**Terex Utilities****SAFETY NOTICE****SN685****DATE:** 4/22/2020**REVISED:****TO:** Owners, Users, Dealers, and Installers**MODELS AFFECTED:** TL80 & TL80/112 Telescopic Aerial Devices**SUBJECT:** Incorrect Level Indicators and Decals**Issue:**

**Figure 1. This bulletin applies if slope indicator and/or decal allows 5 degrees out of level.**

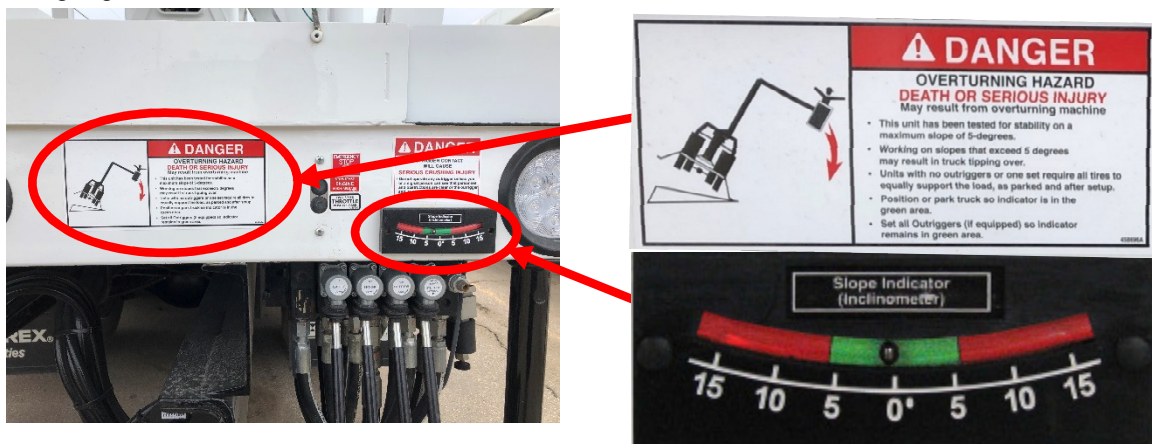
Terex TL80 & TL80/112 telescopic aerial devices, manufactured from March 2019 through March 2020, may be equipped with incorrect chassis slope indicators and overturning hazard decals. The unit must be level for use; however, the incorrect slope indicators and overturning hazard decals were installed which state that the unit can be used up to 5 degrees out of level. **If the unit is used with the chassis out of level it may result in an unstable condition which may cause the unit to tip increasing the risk of injury.**

3. If your unit has the slope indicators with the green band indicating use with the chassis up to 5 degrees out of level and/or a decal which allows use up to 5 degrees out of level, this bulletin applies. Contact Terex Utilities per the contact information in this bulletin to arrange repair and continue to use the machine following the continued use instructions in this bulletin.
4. If your unit has the bullseye slope indicator, which requires the level bubble to be centered, and decal 79584E, which states the unit must be level for operation, this bulletin does not apply and use can continue with the chassis level before operation of the boom.

1. Inform the users of the content of this bulletin and remind them of the daily pre-shift inspection requirements.
2. The chassis must be level before operation of the boom with both the front-to-back and side-to-side chassis level indicators having the steel ball at 0 degrees.
3. Always follow inspection and maintenance requirements as specified in the manuals.

Terex will provide replacement chassis level indicators and decals at no cost to the owner. Field Service kit Z1587, which will contain level indicators and decals, will be provided to the nearest Terex Utilities dealer or Field Service Technician for installation on your unit.
